PROPOSED PLOT PLAN

HEALTH DEPARTMENT
ENVIRONMENTAL HEALTH DIVISION
700 NORTH TRYON STREET
CHARLOTTE, NC 28202
PHONE (704) 336-5102

Installation for 4 bedroom house, located at Lot 11, 25006 Sunfish Court.

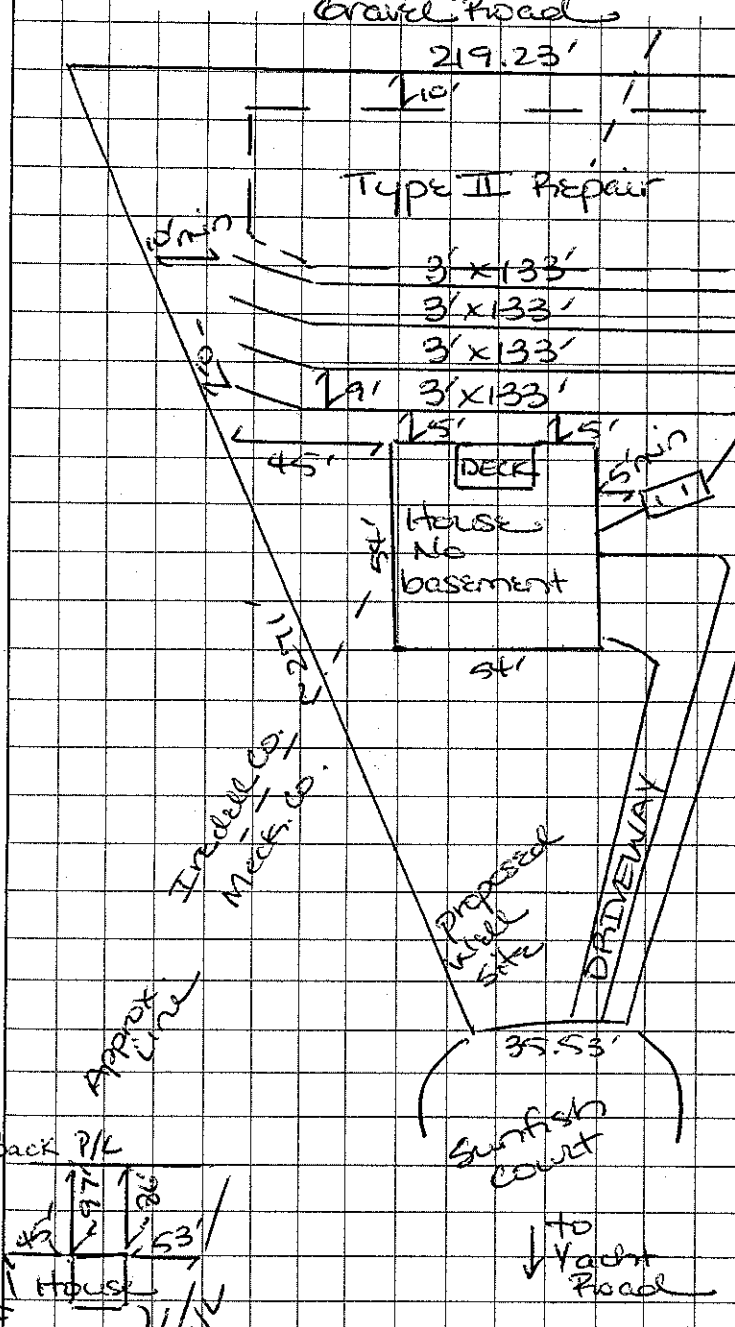
COMMENTS:
- Keep well 100' from septic system or maximum feasible distance, however, no well shall be within 50' of system.
- Any site changes or ~~site plan~~ changes intended use changes may void permit.
- DO NOT DISTURB or GRADE area for septic system + its designated repair area.

Install:
- 1500 gal Septic Tank
- D-Box
- 4 nitrification lines
  - 3' x 133' x 12" stone/gravel
  - Trench Depth 24"-36"
- Divert gutter downspouts away from septic system
- Install surface water diversion ditches to near left and right property lines to divert water away from nitrification field, if necessary.
